Technical Note

Land at Woodgate Centre, Woodgate

20-061-016 Rev -

Response to WSCC Highways Comments

Appendix D Drawing 20-061-014 J

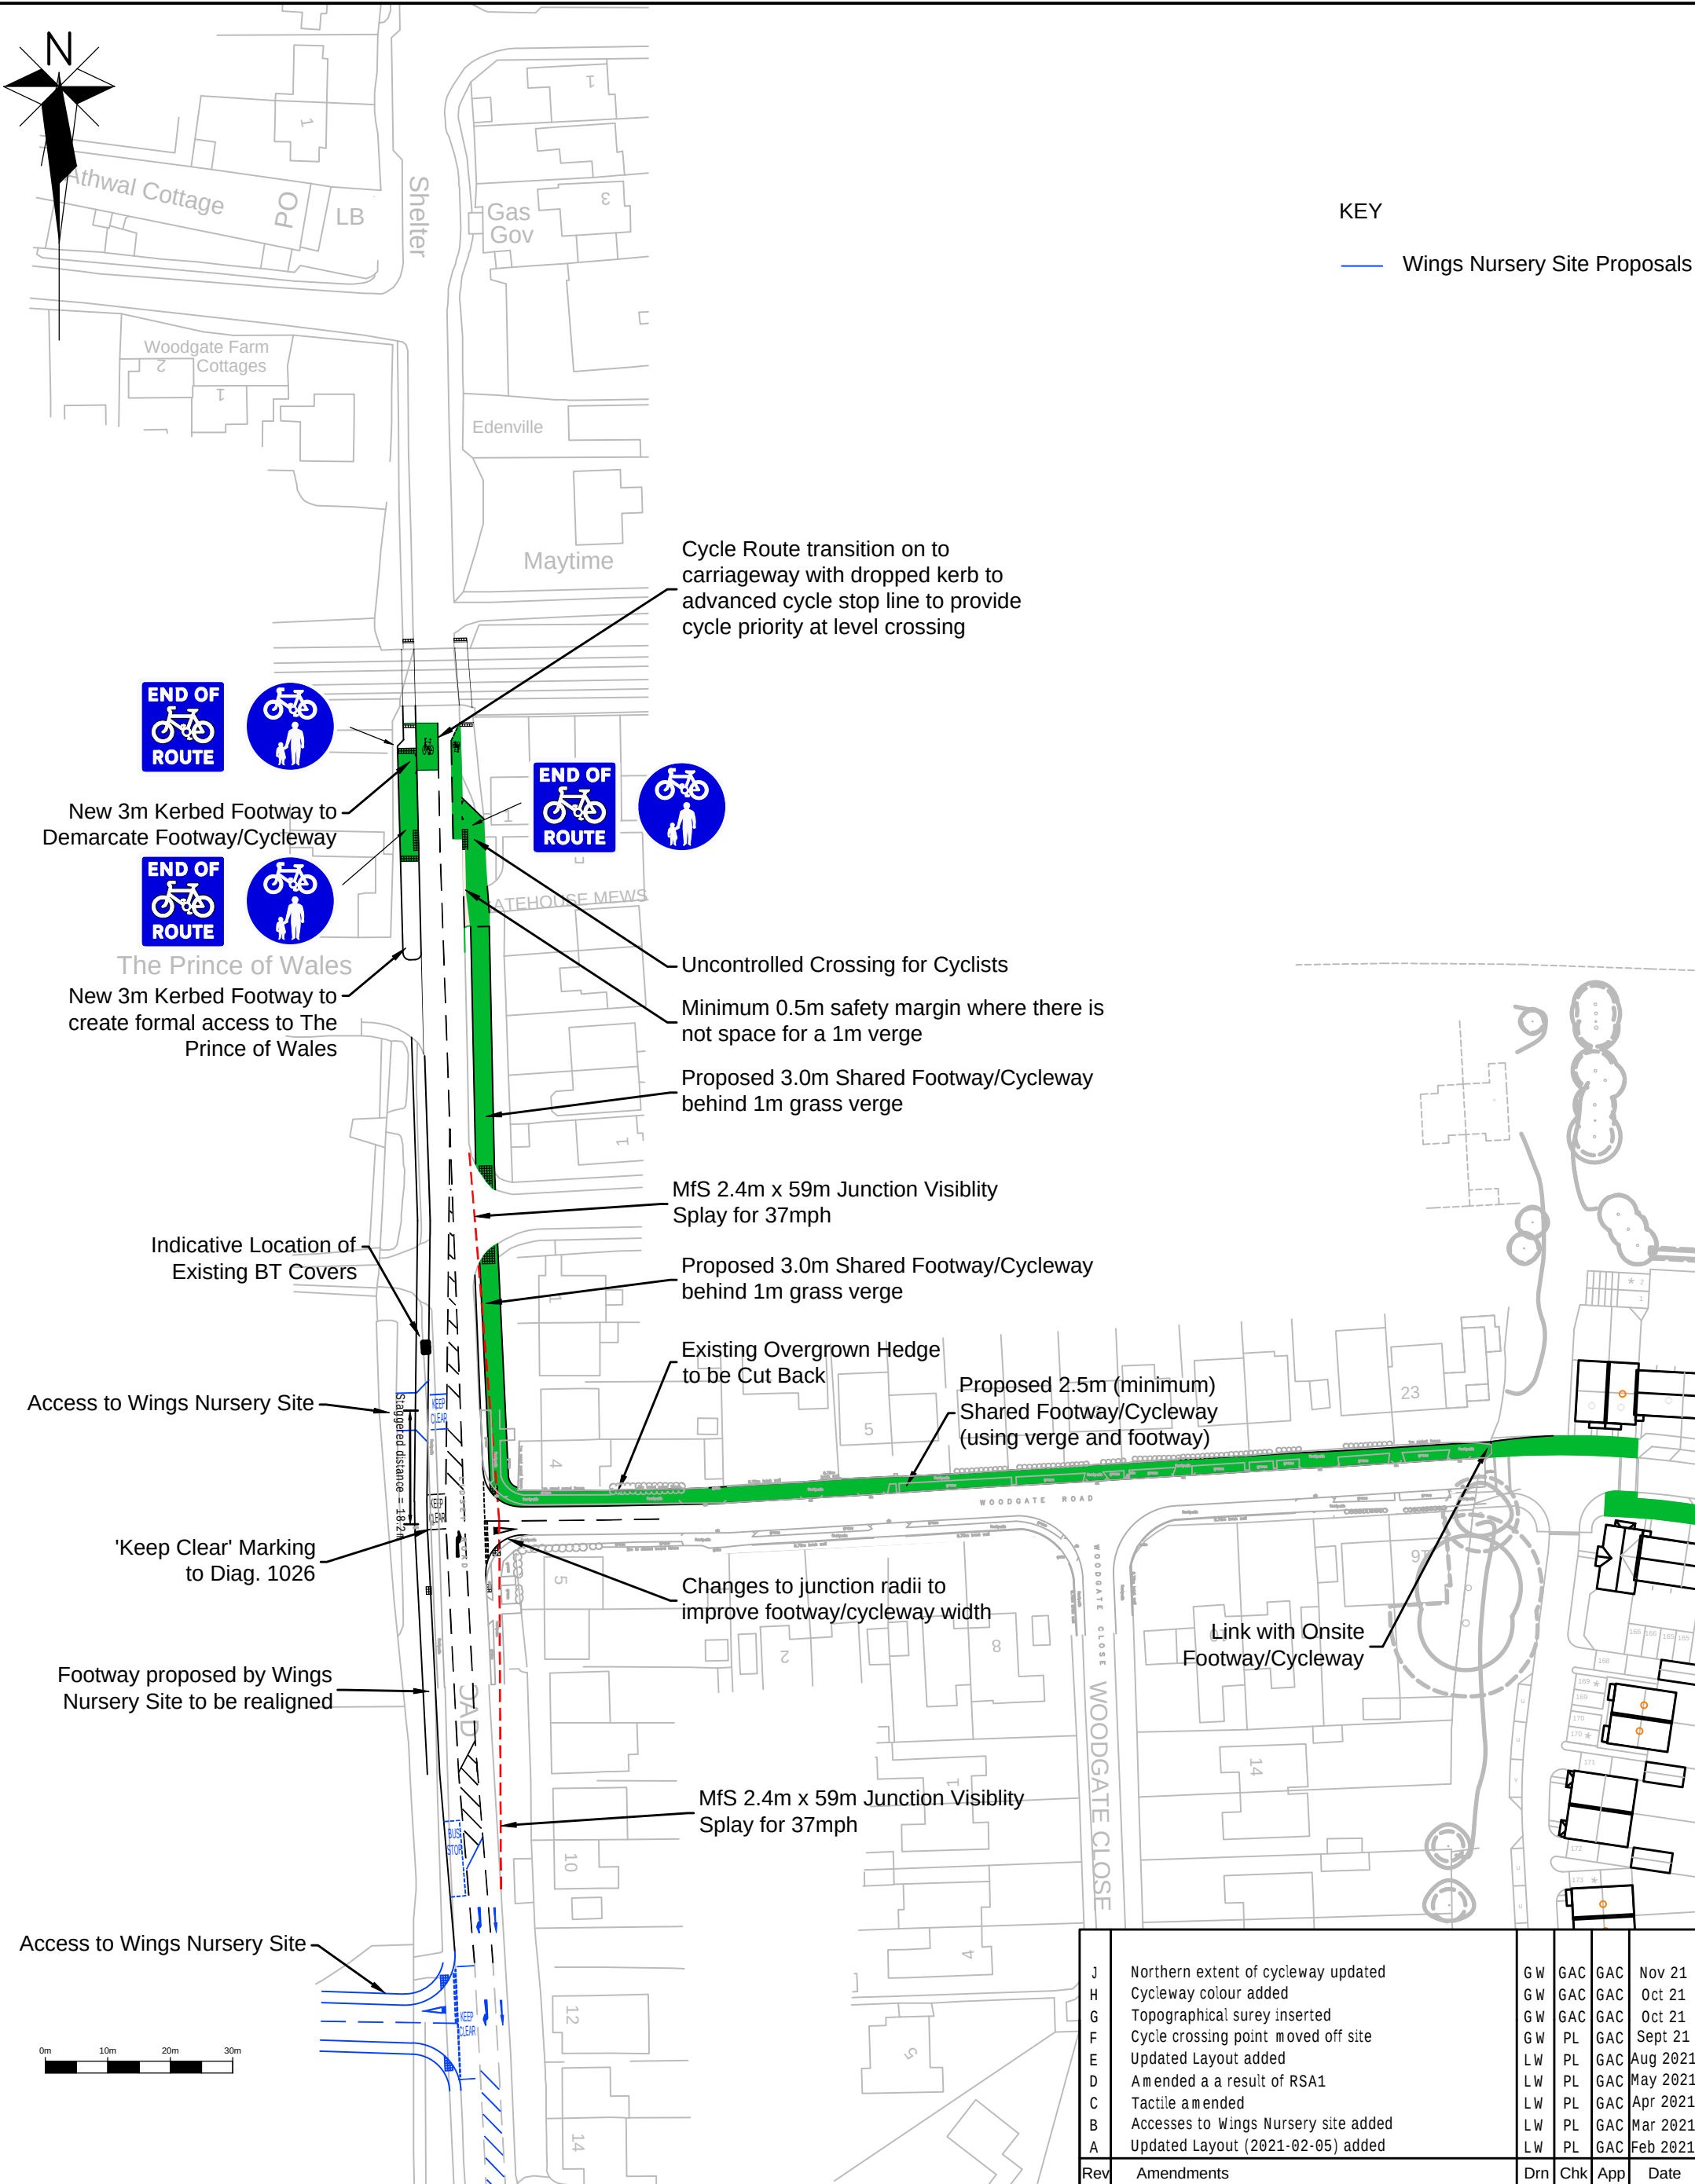
a plan showing how southbound cyclists will be able to leave the carriageway of the A29 and join the off-road cycle way”

“Specifically with regard to item 2.2 in the Road Safety Audit, the CHA still considers that the audit team recommendation of terminating the route south of the railway crossing be pursued for the reasons already given (please see WSCC response dated 17th September 2021). Should the applicant disagree with this then a formal ‘Exception’ would need to be considered by the CHA.”

- 2.1.4 Drawing 20-061-014 to revision J (**Appendix D**), has been updated to provide a dropped kerb to allow cyclists from the north to join the cycle route. This has been positioned between the level crossing and the private drive opposite the Prince of Wales. This revision also removes the northbound cycle route north of the level crossing as requested by WSCCH, under their point 5.

- 6.1.1 As highlighted above we have taken on board the recommendation to remove the cycle route north of the level crossing, this is shown on drawing 20-061-14 revision J, within **Appendix D**.

J	Northern extent of cycleway updated	GW	GAC	GAC	Nov 21
H	Cycleway colour added	GW	GAC	GAC	Oct 21
G	Topographical surey inserted	GW	GAC	GAC	Oct 21
F	Cycle crossing point moved off site	GW	PL	GAC	Sept 21
E	Updated Layout added	LW	PL	GAC	Aug 2021
D	Amended a a result of RSA1	LW	PL	GAC	May 2021
C	Tactile amended	LW	PL	GAC	Apr 2021
B	Accesses to Wings Nursery site added	LW	PL	GAC	Mar 2021
A	Updated Layout (2021-02-05) added	LW	PL	GAC	Feb 2021
Rev	Amendments	Drn	Chk	App	Date
